APPLICATION FOR PERMISSION  
UNDER SECTION 16 OF  
THE TOWN PLANNING ORDINANCE  
(CAP.131)

For Official Use Only 請勿填寫此欄	Application No. 申請編號	A/K:1/266
	Date Received 收到日期	29 JUL 2022

**S16 PLANNING APPLICATION  
APPROVED TSIM SHA TSUI OUTLINE ZONING PLAN NO. S/K1/28**

**Comments on Planning Application (Application no.: A/K1/266)**

Image 1487 - curve on slip road

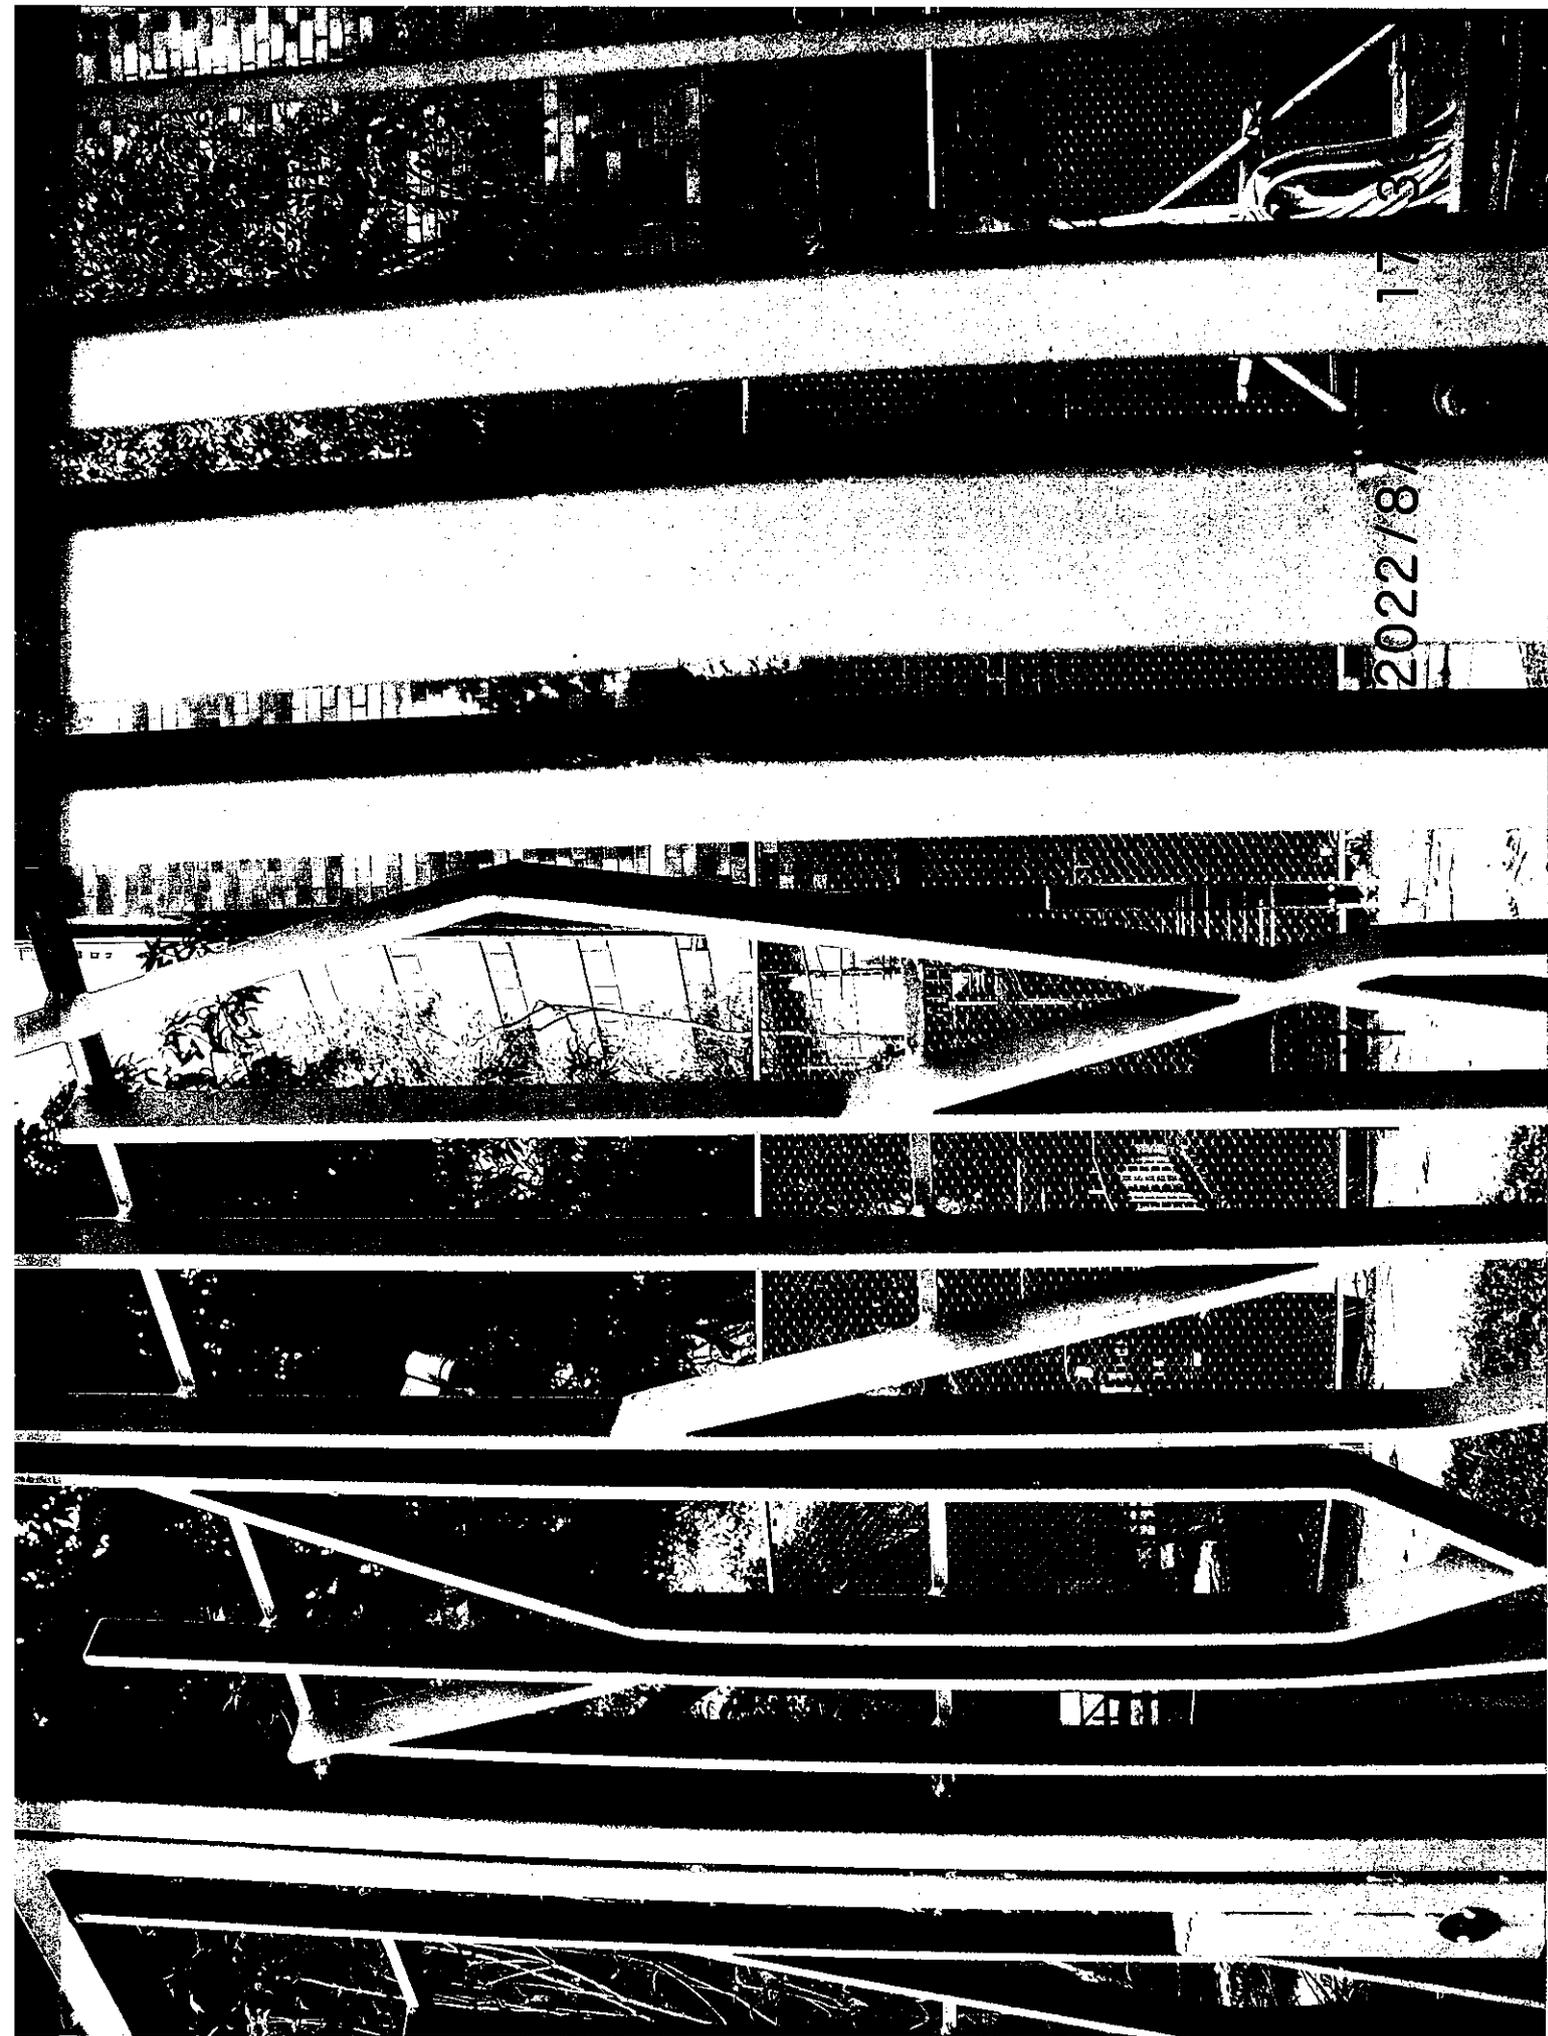
We have strong objections to this plan as it will create a wall effect along Chatham Road South. This is a most busy road prone to frequent bumper to bumper traffic conditions and extensive vehicle emissions. The proposed building would be very close to the road, as can be seen from the images, while currently there is a setback and row of trees that provide a buffer zone.

It would entail the chopping down of numerous trees that not only provide visual relief but also help to alleviate air pollution both to the university, the roads/pavements, and the surrounding district.
